CHANGE ORDER PROPOSAL NO.: 9

PROJECT: Bethel PD Training Range

COP #009 - RFI #009 - Enable Installation of MAU Duct Supports

ROOF DUCT SUPPORT DETAIL

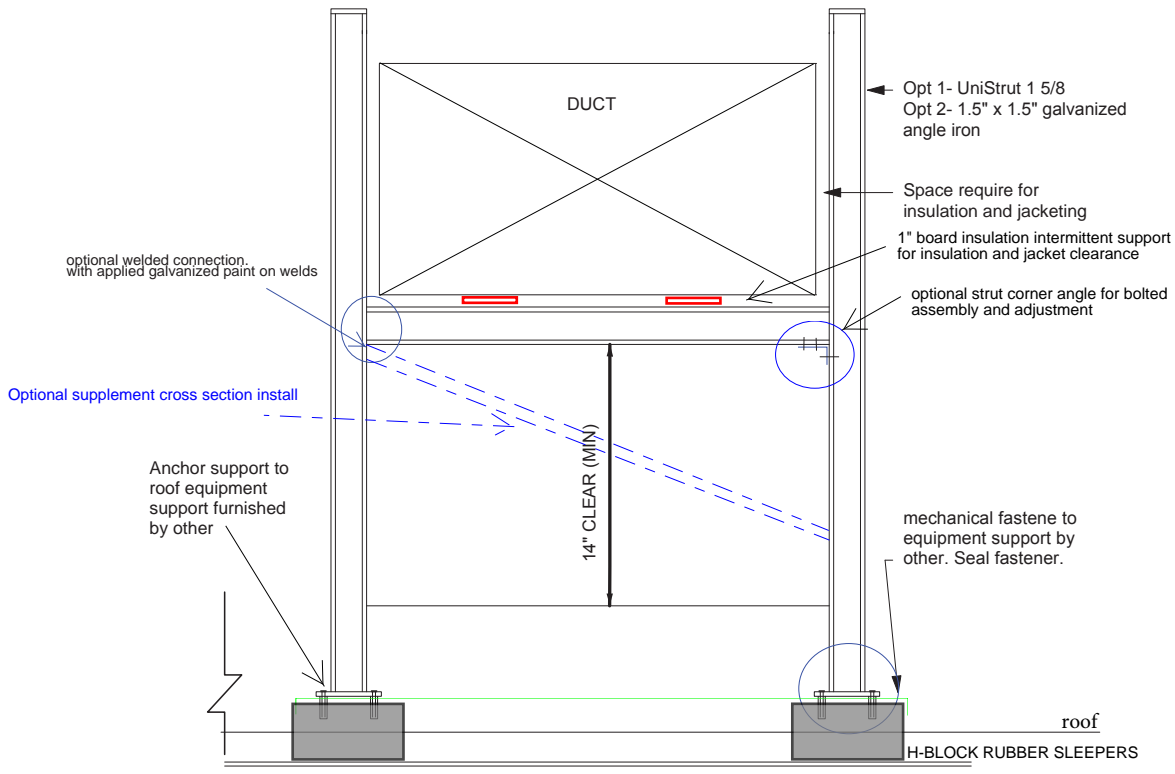
This COP includes all labor, and material to hand dig a trench, install filter fabric, and place crushed stone at (4) locations, As explained by Action Target's HVAC subcontractor, the 34x32 MAU duct work supports get mounted to H-block rubber sleepers, and it's not recommended to bear directly on topsoil. Instead of concrete, crushed stone is a suitable alternate. Layout of trench locations will need to be provided by others.

See attached drawing showing exterior ductwork supports. Since the existing MAU slab is not being expended to their desired dimensions, the recommendation was made to place 4" of #4 stone at the indicated locations, to provide bearing capacity for the H-Blocks. Based upon the provided weights please review and advise if there are any concerns with the amount of stone be proposed. Are there any drainage concerns? Should filter fabric be installed under the gravel base?

The scope of the signed Architectural/Engineering Services agreement between Jacunski Humes Architects, LLC and the Town of Bethel, dated March 3, 2022 does not include Site nor Structural services to accomplish this request. The agreement specifically excludes Consulting Services not included in the Proposal.

The Action Target drawings specifically state the support of the unit's ductwork is the responsibility of the Owner.
